**ENFORCEMENT CONFERENCE AGENDA  
DUKE POWER COMPANY  
9:30 A.M., JULY 1, 1988  
NRC/REGION II HEADQUARTERS BUILDING  
ATLANTA, GEORGIA  
ENVIRONMENTAL QUALIFICATION OF EQUIPMENT**

**ENFORCEMENT CONFERENCE AGENDA  
DUKE POWER COMPANY  
OCONEE NUCLEAR STATION  
9:30 A.M., JULY 1, 1988  
NRC/REGION II HEADQUARTERS BUILDING  
ATLANTA, GEORGIA  
ENVIRONMENTAL QUALIFICATION OF EQUIPMENT**

**ENFORCEMENT CONFERENCE AGENDA  
DUKE POWER COMPANY  
CATAWBA NUCLEAR STATION  
JULY 1, 1988  
NRC/REGION II HEADQUARTERS BUILDING  
ATLANTA, GEORGIA  
ENVIRONMENTAL QUALIFICATION OF EQUIPMENT**

**Reactor Building Level  
Transmitter Oil Level Not to Top  
of Junction Box**

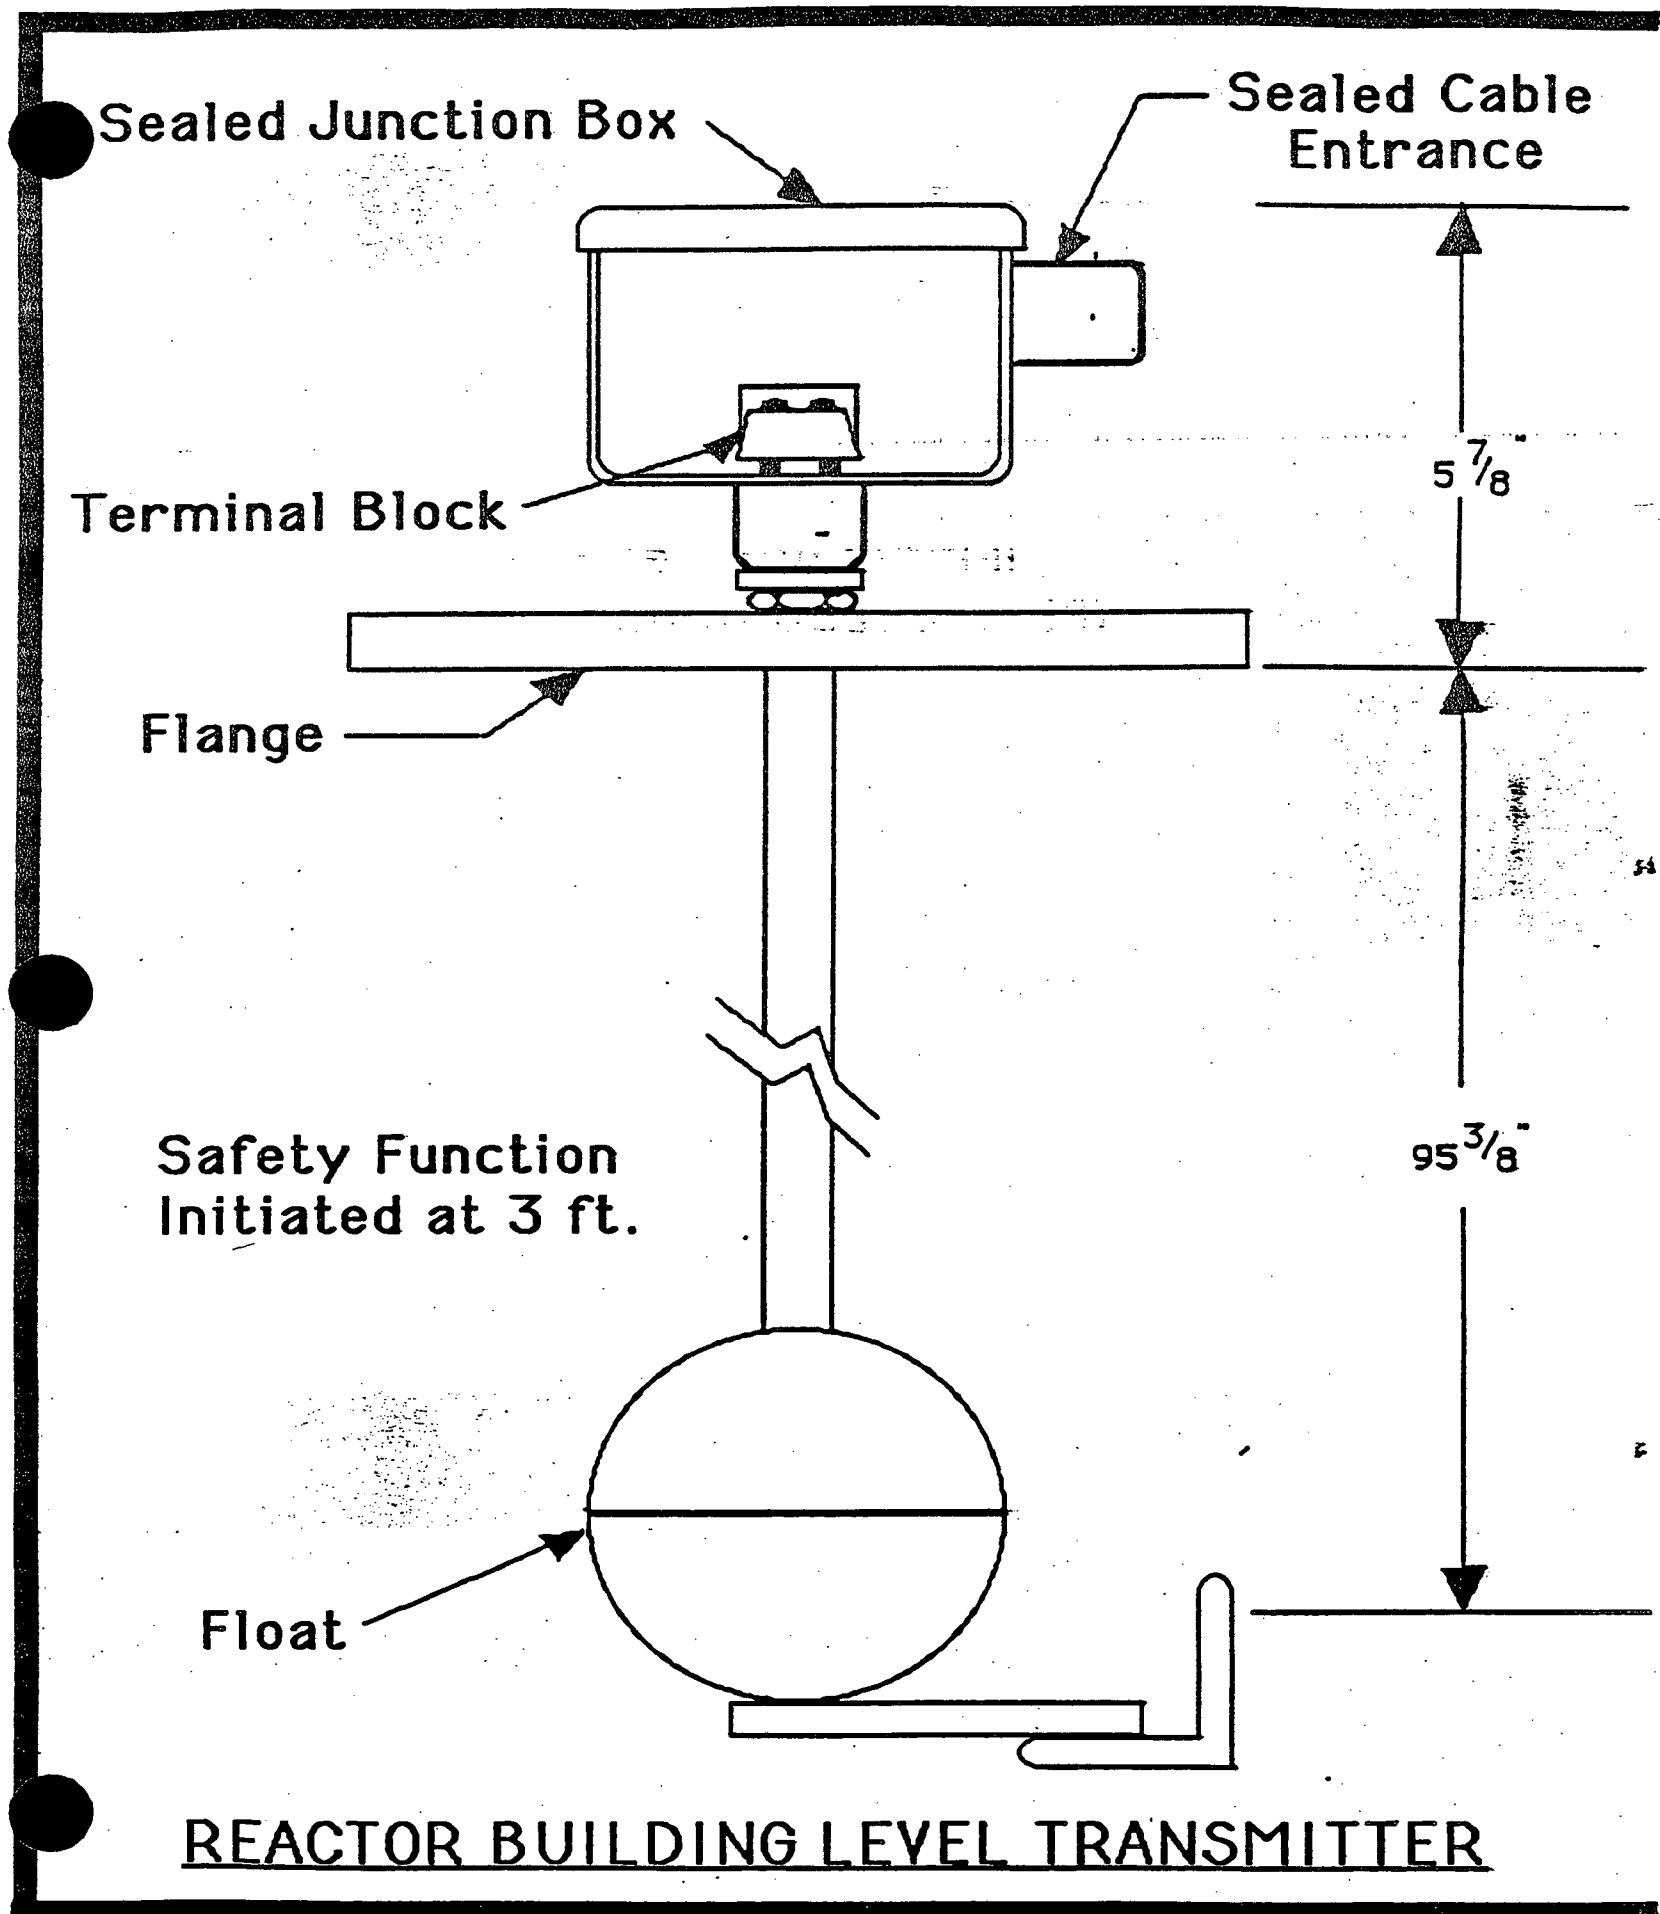
- **During the walkdown the inspector noted that the oil level in the Reactor Building level transmitter junction box was not to the top and not in the "as-tested" configuration.**
- **The oil level had been lowered during a maintenance activity after initial installation and was not fully refilled.**
- **The junction box is gasketed and the cable entrance is sealed.**
- **Duke demonstrated during the inspection the condition was qualifiable for this application.**
- **Duke evaluation was found acceptable.**
- **Procedure revised to require verification of proper oil level each refueling outage.**

- ***It is Duke Power Company's position that this violation falls under Paragraph III of the enclosure to Generic letter 88-07(i.e., not sufficiently significant to be considered for escalation, and should be considered a severity level IV or V).***

**88-03-05 : Inadequate Documentation of  
Installed Configuration for the  
Victoreen High Range Radiation  
Monitors**

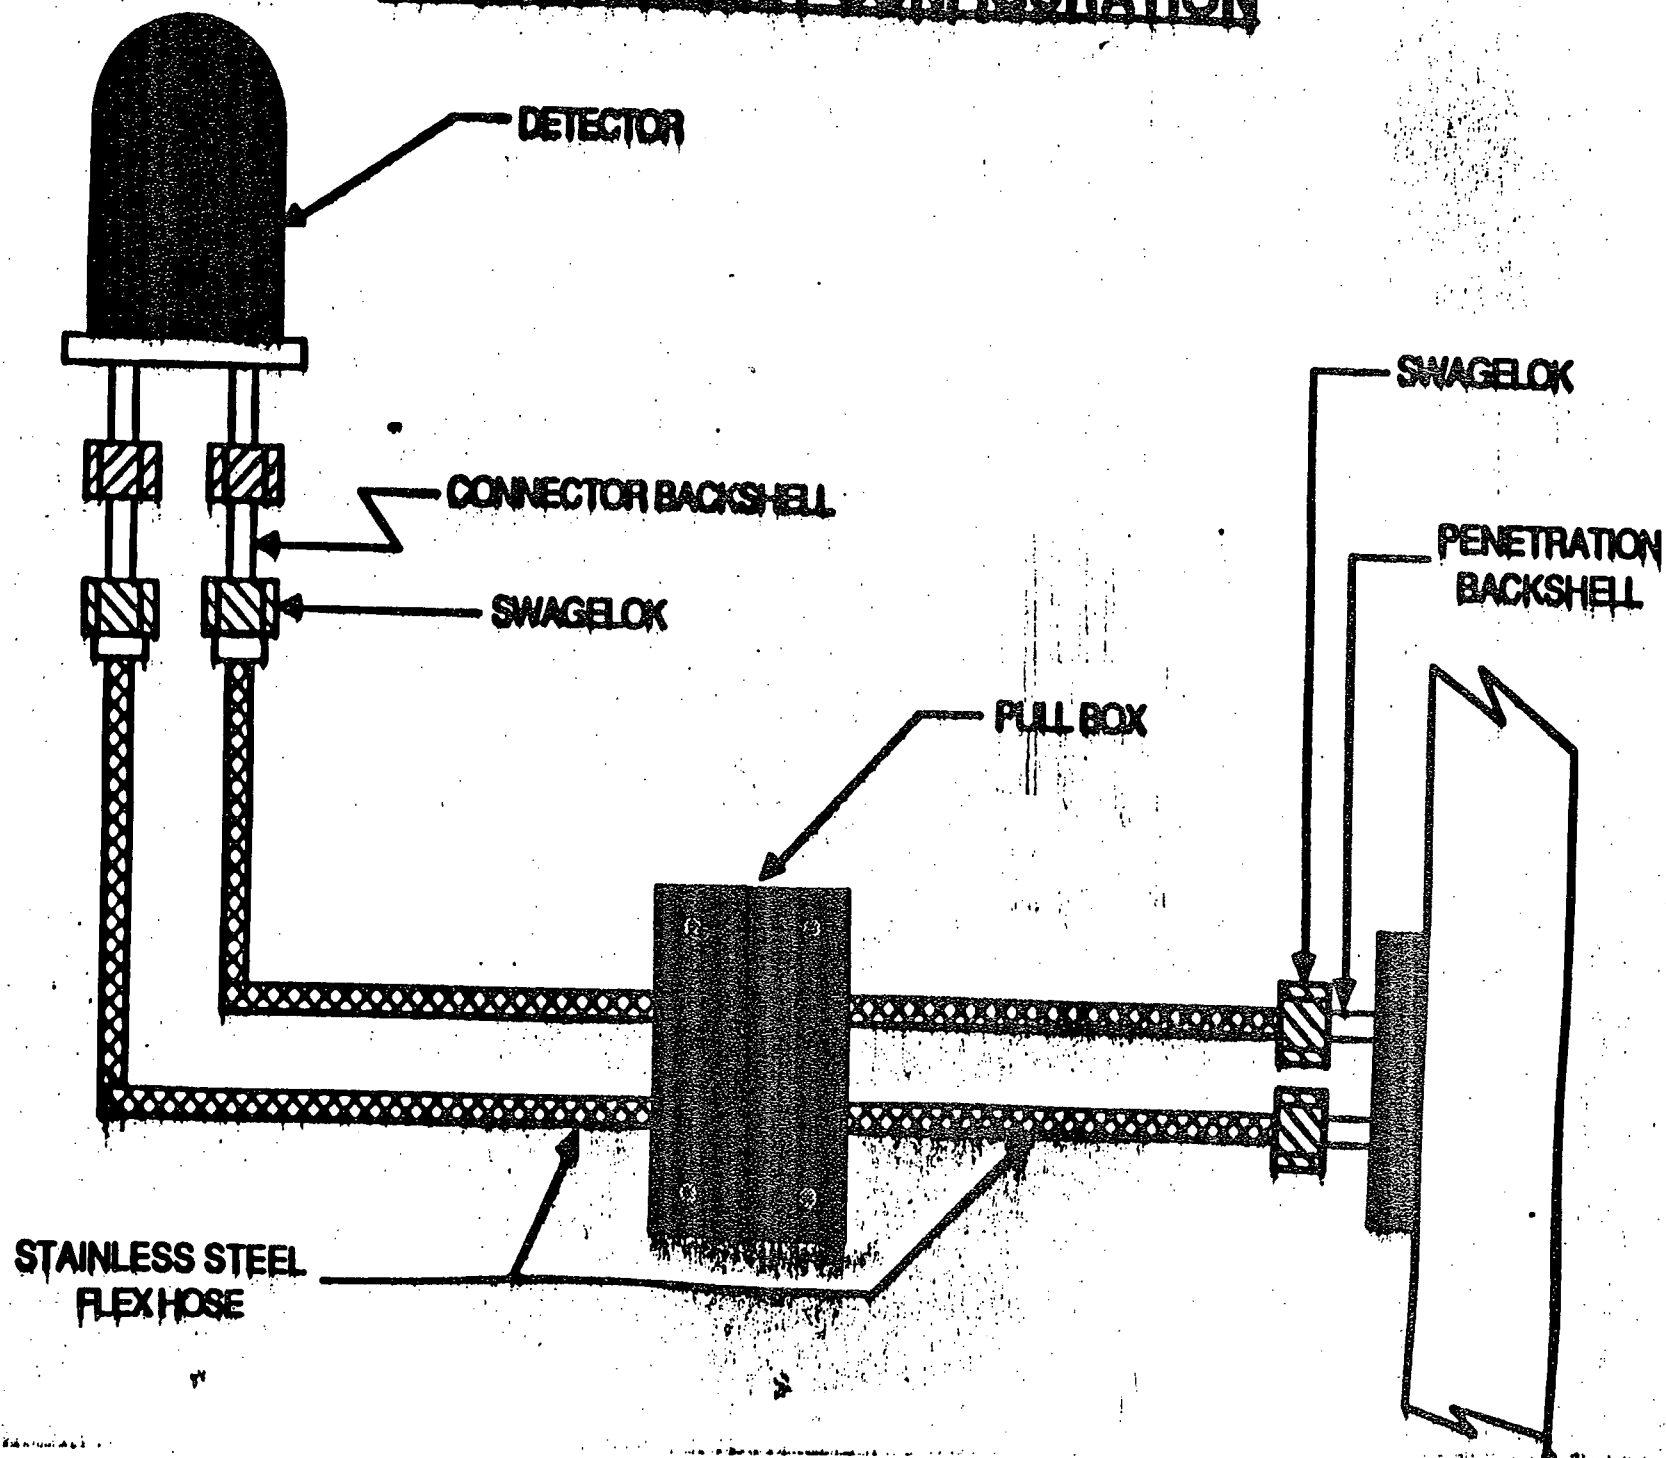
- **Victoreen Configuration**
  - **Detector with integral male connector**
  - **Pigtail with female connector (pigtail coax soldered to back of female and potted, covered by braided hose with swagelok)**
  - **Junction box**
  - **Field cable with penetration connector**
- **Duke experienced operational problems with Victoreen connectors and junction box**

- **Duke made decision(August 8, 1983) to replace all connectors and junction box with Duke qualified cable, Duke qualified splices, and Duke qualified potting**
- **Victoreen reviewed and provided on site assistance during initial installation(August 9, 1983)**
- **Qualification reports on file during audit for all segments of Duke modification**
- **Victoreen EQ report had not been addended to reference Duke reports**
- **Duke drawings reflected the installed Duke design**
- **Duke configuration is fully qualified**
- **Victoreen EQ files have been supplemented for clarification**

**88-07-02 : RCS Wide Range RTDs not  
Installed in accordance with  
Tested Configuration.**

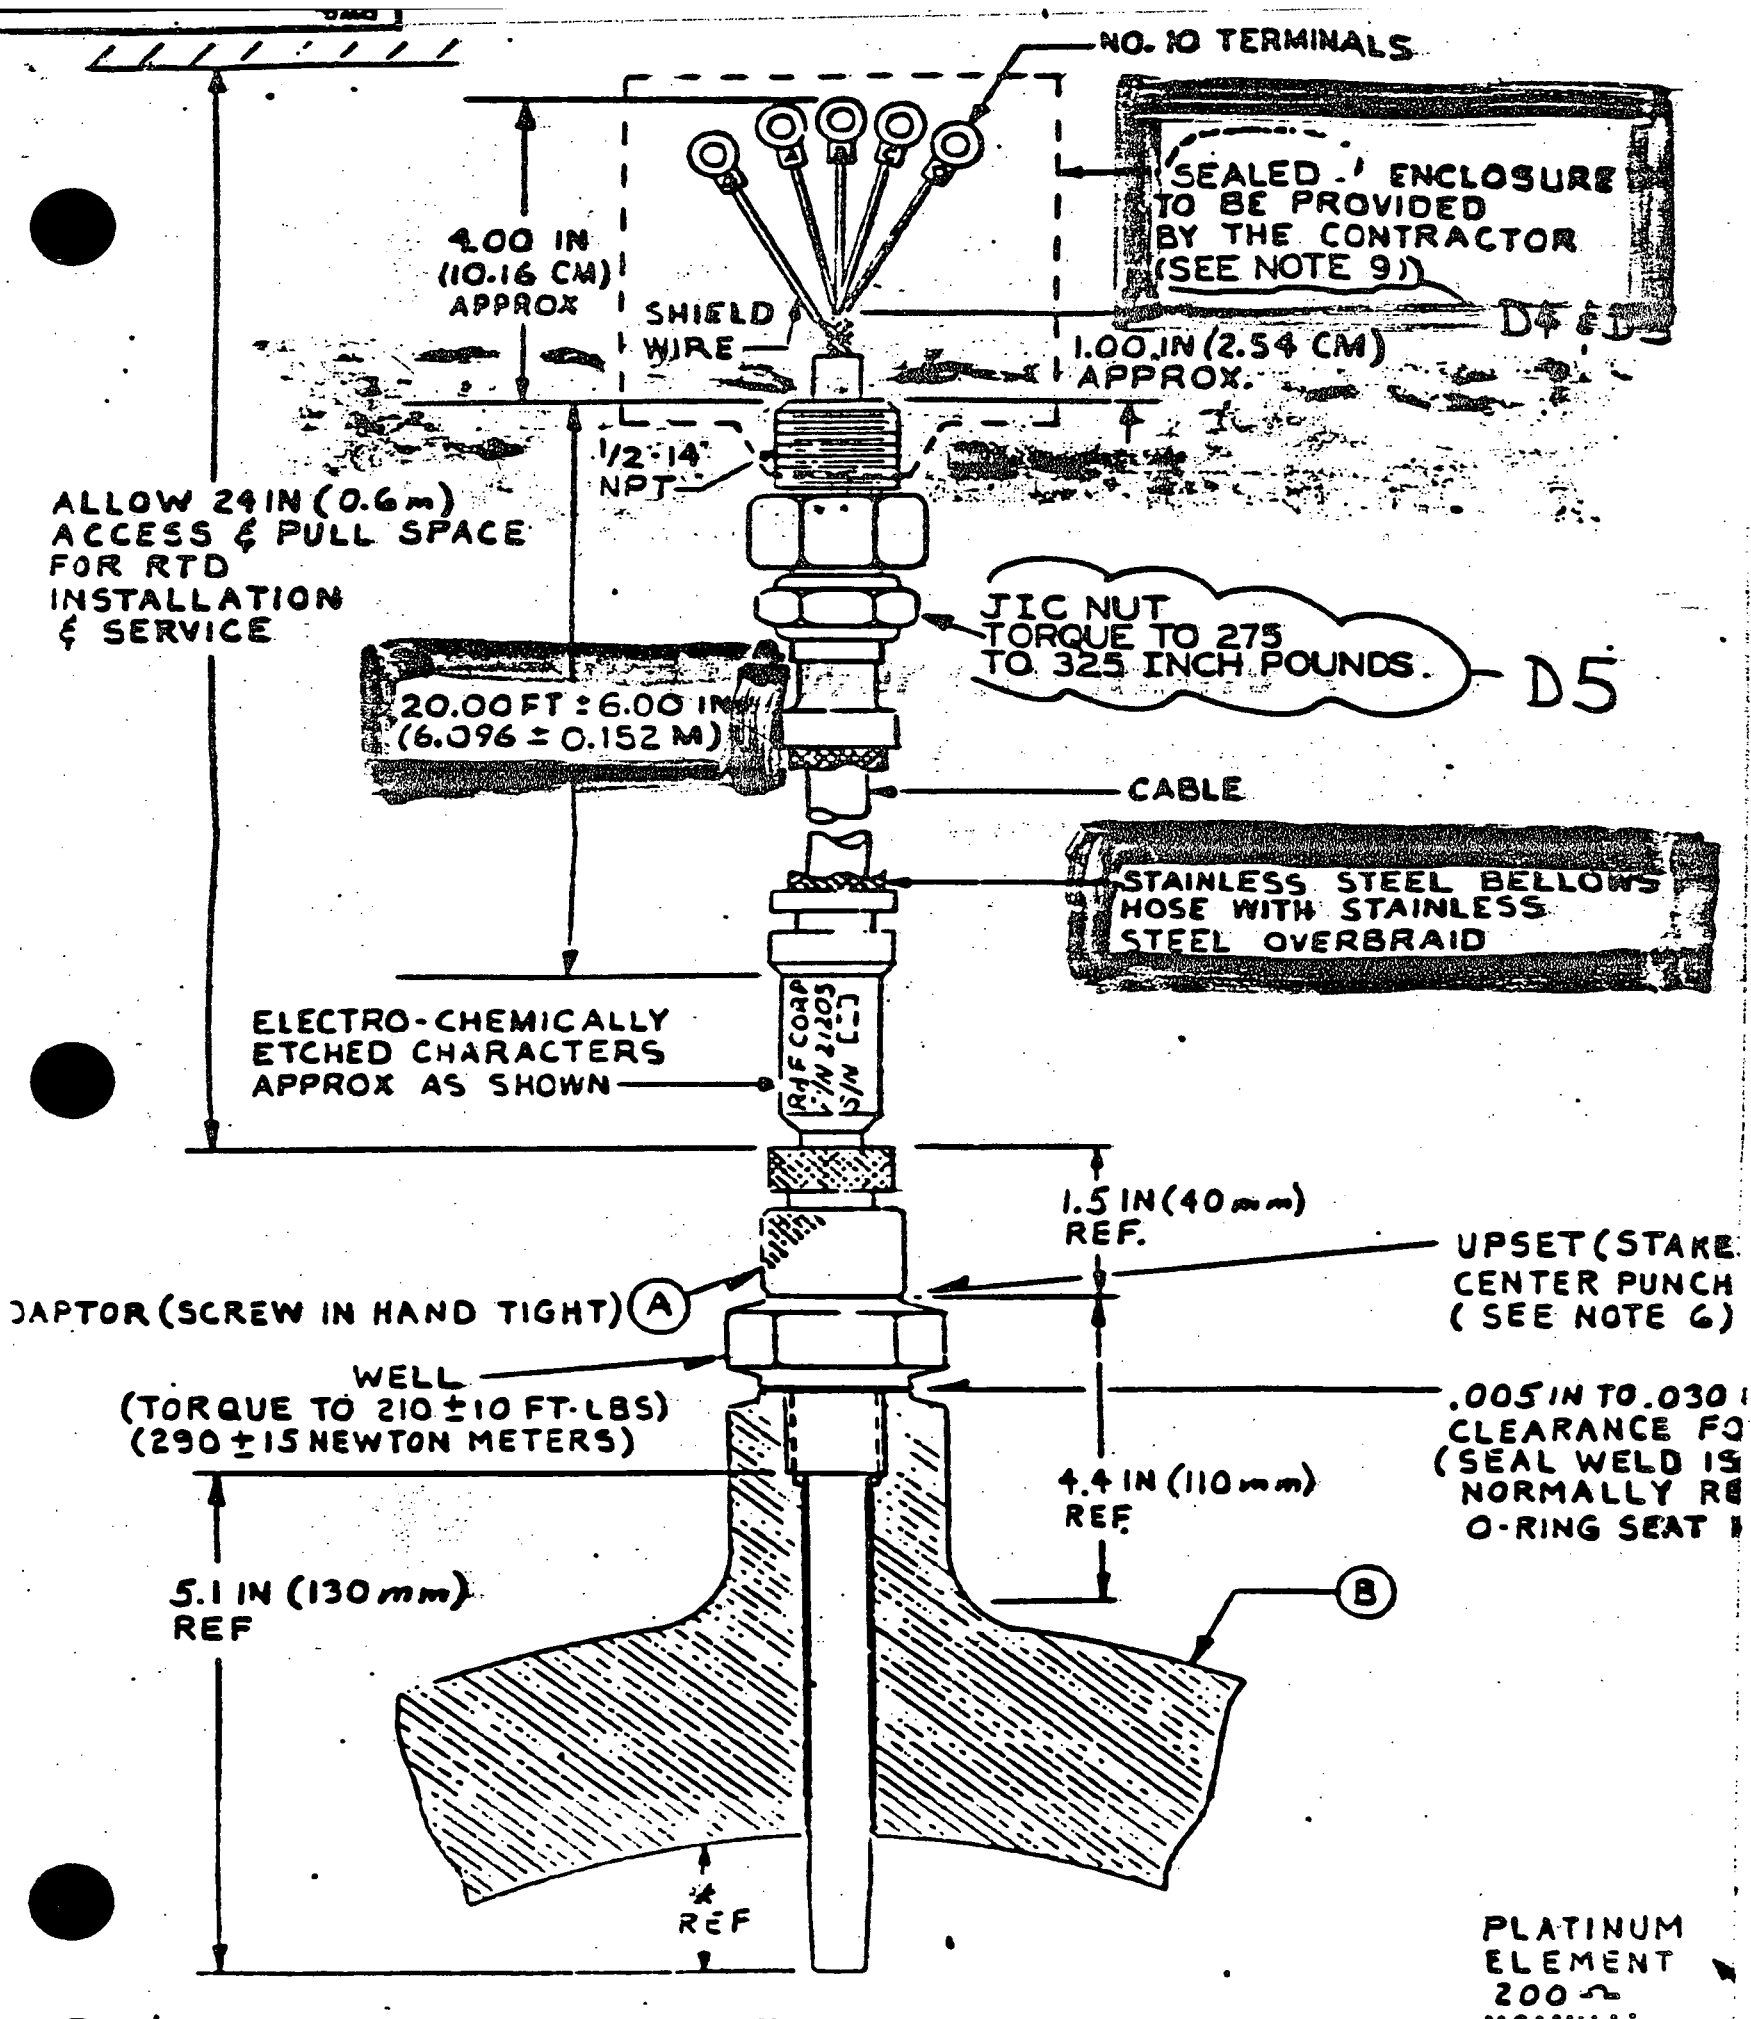
- **Licensee identified violation, reported by LER, and corrected prior to inspection.**
- **During an inspection of Raychem splices by Design Engineering, the NEMA 4 junction box for the RTD/cable splice was questioned in regard to meeting the vendor requirement for a "sealed" box.**
- **The condition was evaluated by Design Engineering to be operable, but a modification was made to pot the entire junction box to minimize moisture induced leakage current effects on instrument accuracy.**
- **In the process of finalizing the modification, an installation error was detected.**

- **An unqualified condition had resulted from misinterpretation of notes on drawings during initial installation.**
- **Duke standard practice is to add flex conduit for additional mechanical protection if vendor supplied cable is not armored.**
- **RTDs are provided with braid, not armor.**
- **Craft had inadvertently removed underlying bellows in attempt to replace braid with flex conduit.**
- **As noted in the inspection report, the fix is fully qualified and no finding was identified for the EQ package.**
- **It is Duke Power Company's position that the original installation was unqualified.**
- **The condition was identified, reported, and corrected by Duke prior to the inspection.**

- **Duke does not consider this item to meet the criteria (Generic Letter 88-07, Section II) for "clearly knew or clearly should have known"**
- **In that regard, this specific equipment was evaluated during the March 6-8, 1984 NRC EQ audit of Catawba (prior to receipt of Unit 1 fuel load license):**
  - \* **The installation deficiency was very difficult to detect, even by experienced walkdown personnel!**
  - \* **As documented in the Catawba SER, this equipment was specifically inspected to verify the installation was consistent with the qualification documentation.**
  - \* **The installation deficiency was not detected, even though it was a specific objective of the walkdown.**
